FLAT CREEK ADDITION

WICHITA, SEDGWICK COUNTY, KANSAS

RE: SUB 2001-28 -- Revised One-Step Final Plat of Flat Creek Addition

RE: SUB 2001-28 - One-Step Final Plat of Flat Creek Addition

FLAT CREEK ADDITION

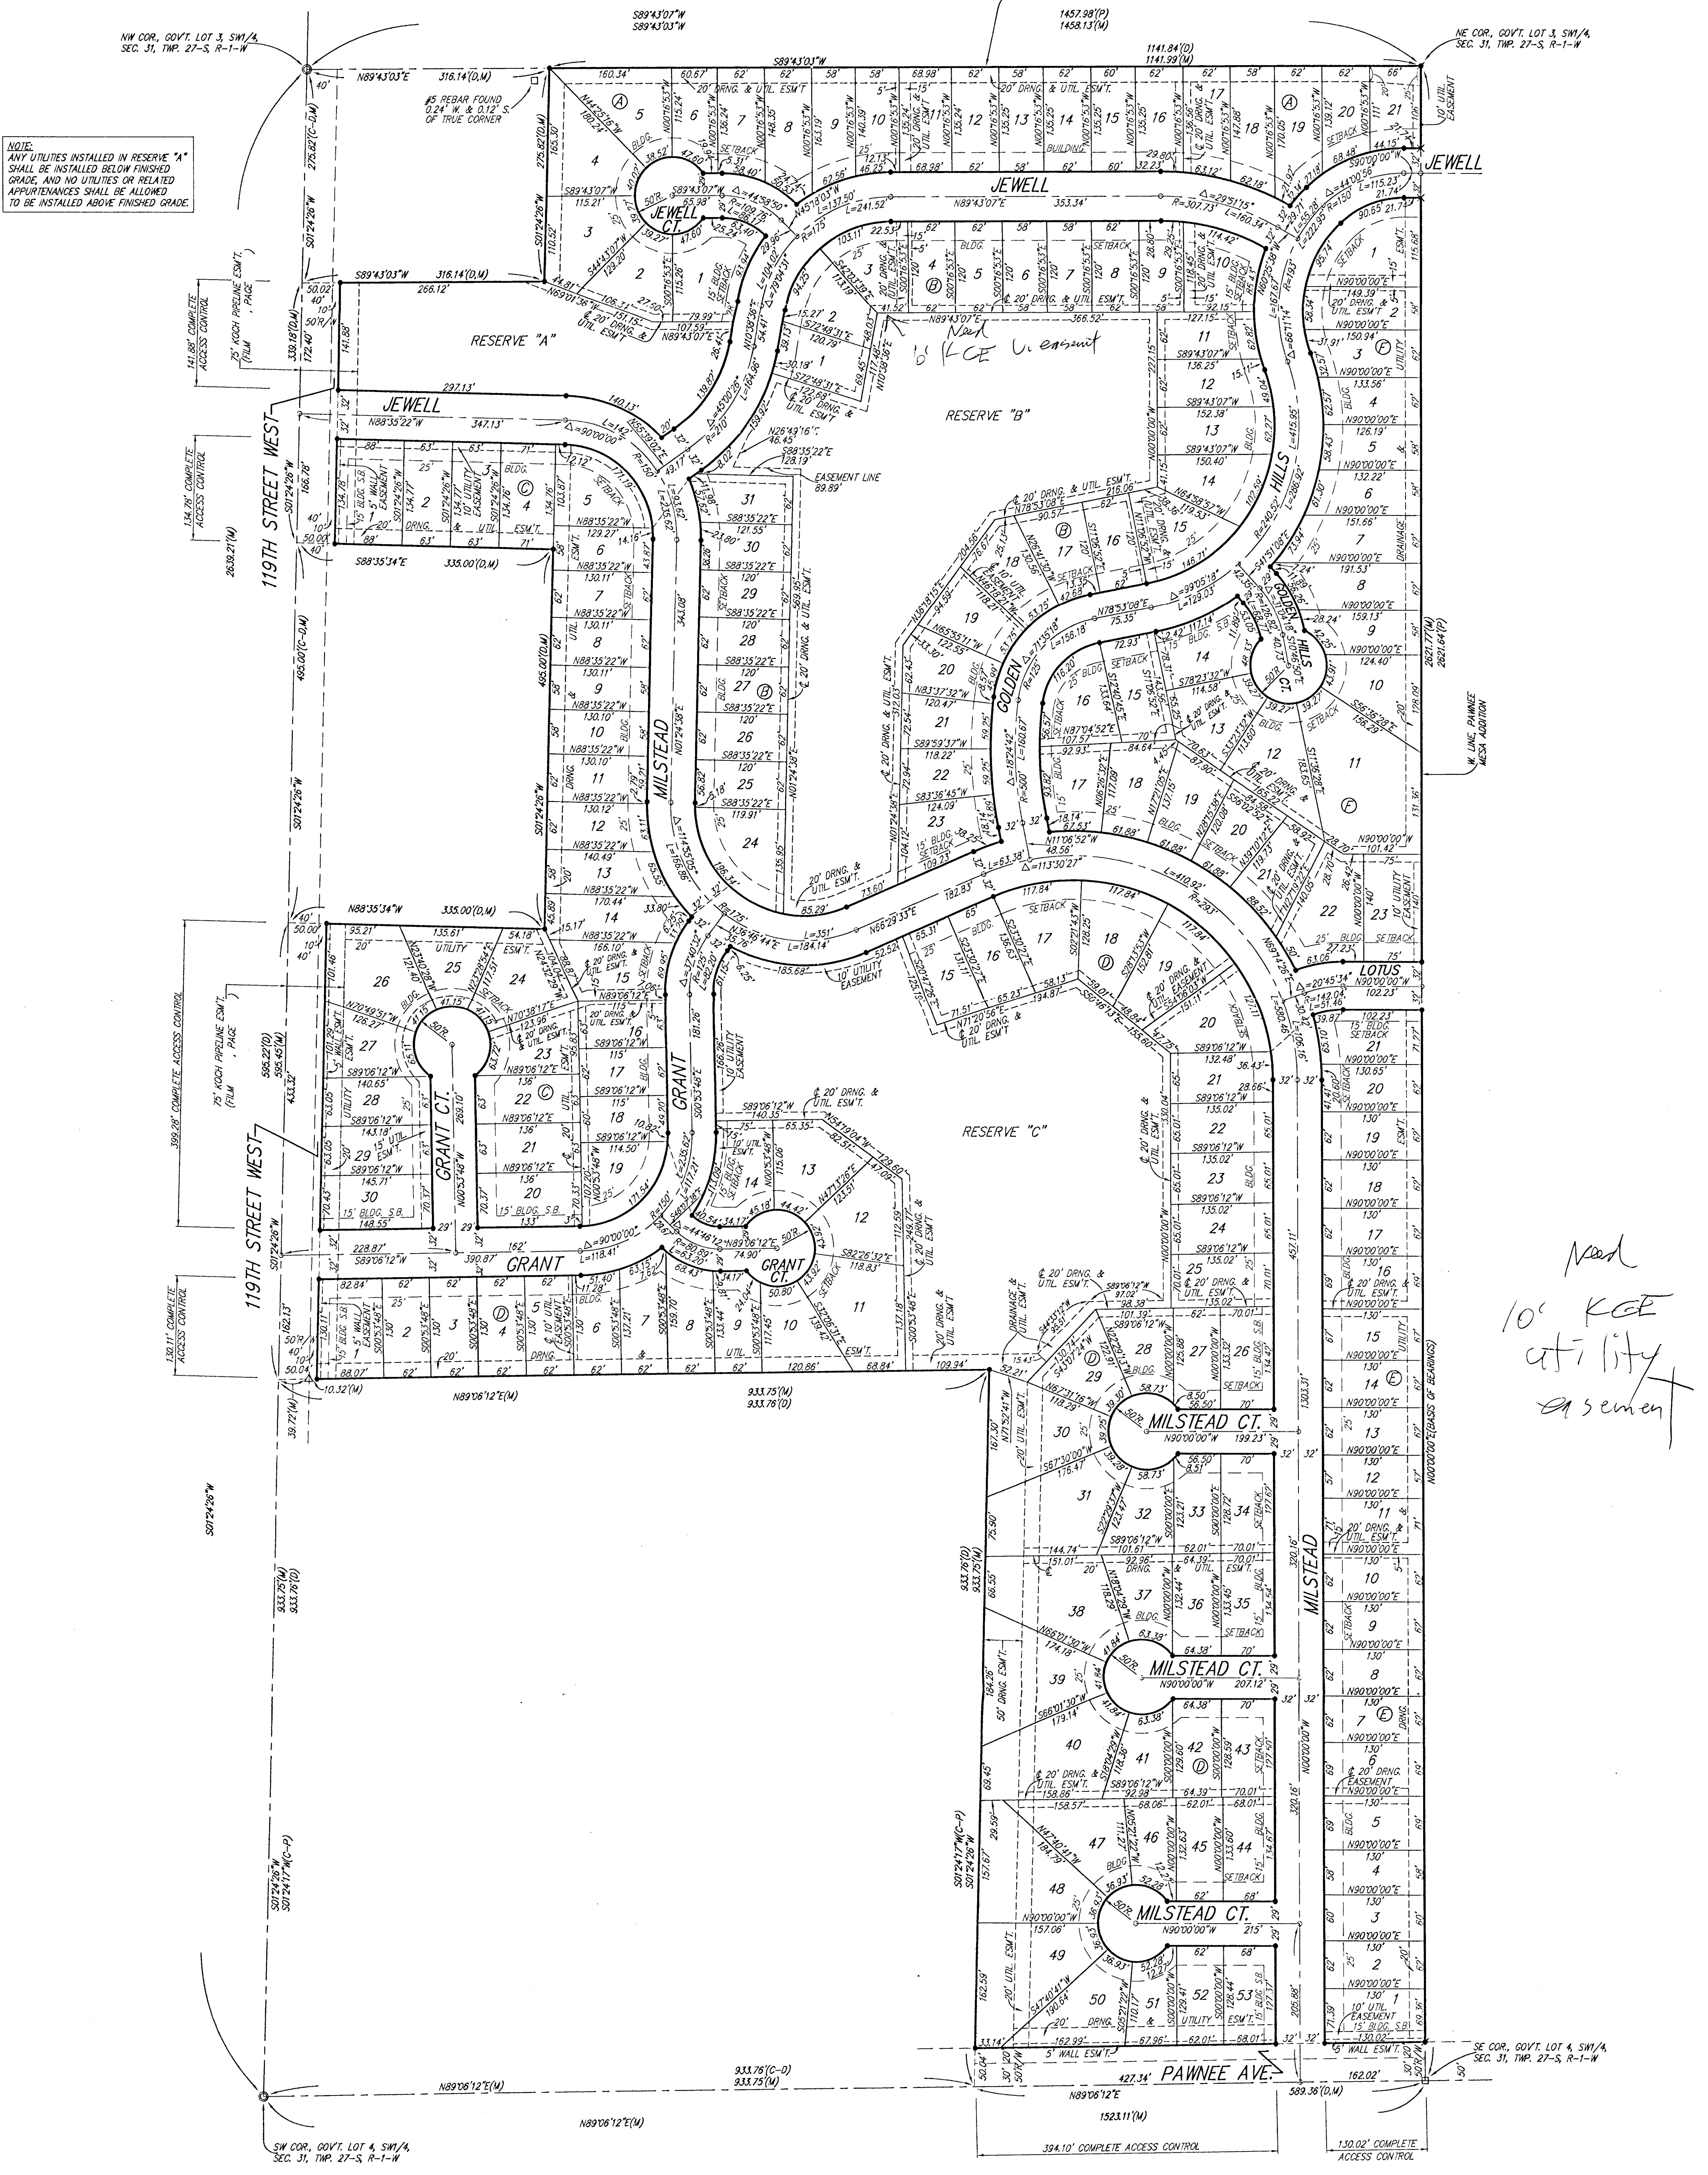
- E. County Engineering needs to comment on the need for improvements to perimeter streets. No improvements are required.
- F. The plat proposes complete access control along the plat's frontage to Pawnee and 119th St. West. The final plat shall reference the access controls in the plat's text.

- J. It appears that the width of the through street and loop streets are measured as 64 feet although incorrectly labelled as 70 feet.
- K. Lots 7, 8 and 11, Block F, exceed the maximum lot width to lot depth ratio of 2.5 to 1. A modification has been approved by the Subdivision Committee.

- N. The applicant needs to verify the location of the pipeline easement indicated in the platting binder. If this easement is on this site, it should either be shown or verification provided that it is off-site or has been released.

- J. It appears that the width of the through street and loop streets are measured as 64 feet although incorrectly labelled as 70 feet.
- K. Lots 7, 8 and 11, Block F, exceed the maximum lot width to lot depth ratio of 2.5 to 1. A modification has been approved by the Subdivision Committee.

- O. The applicant needs to verify the location of the pipeline easement indicated in the platting binder. If this easement is on this site, it should either be shown or verification provided that it is off-site or has been released.
